# Recall Campaign Bulletin

Campaign No. 2023010002, February 2023

SUBJECT: **Model GLE/ML and GLE Coupe (166 and 292 platform)**  
**Model Year 2012-2019**

## **Check for Water entry in the Spare Wheel Well**

**Figure 1**

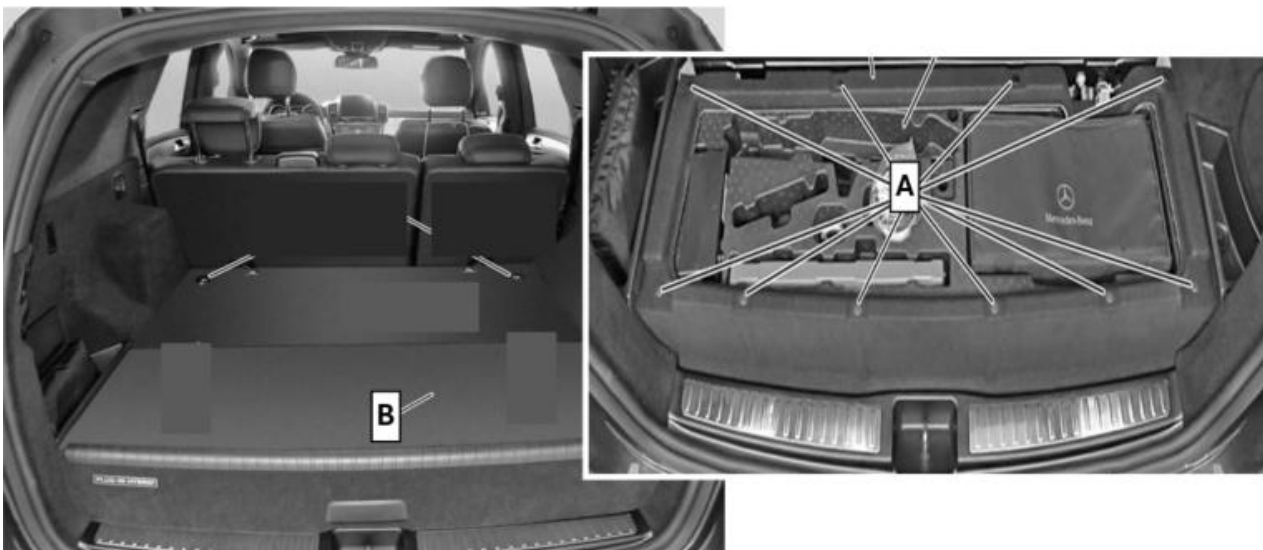
1. Open trunk.
2. Lift spare wheel well cover and secure it from falling down.
3. In vehicles with emergency wheel code 690, remove emergency wheel and cover located below , (Figure 1).

Figure 23

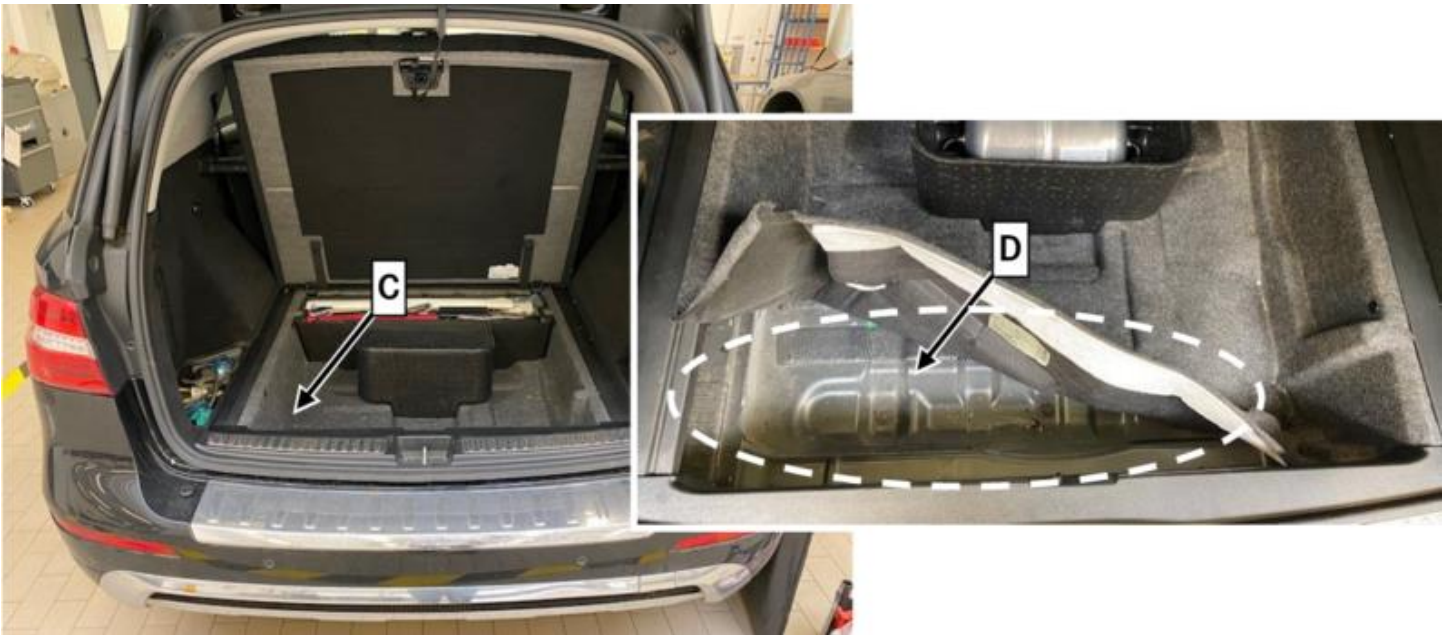
5. Lift left rear felt insert (C, Figure 3) and check for humidity or water deposits in marked area (D, Figure 3).

- a. If humidity or water deposits are **not** present in area (D, Figure 3): Carry out **work procedure A**.
- b. IF humidity or water deposits are present in area (D, Figure 3): Carry out **check/test procedure B**.

Figure 6

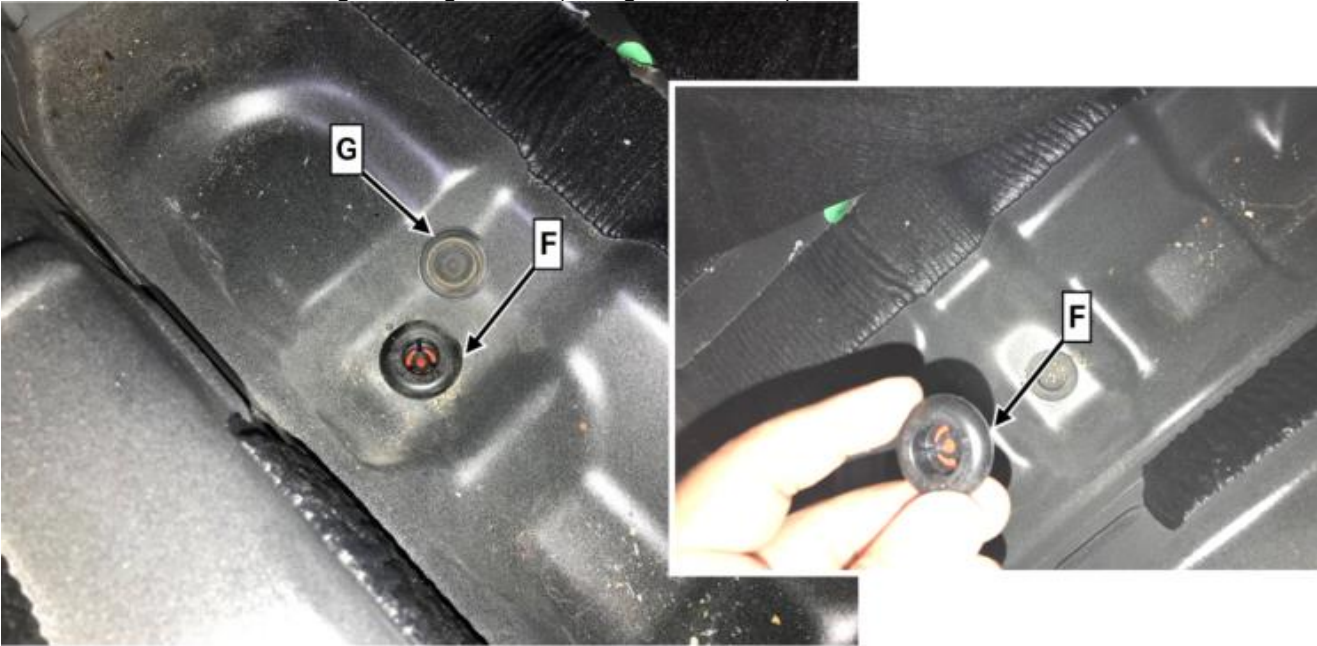
1. Retrofit new water drain grommet (F, Figure 6).

**i** First, remove existing closed grommet (G, Figures 6 and 7).
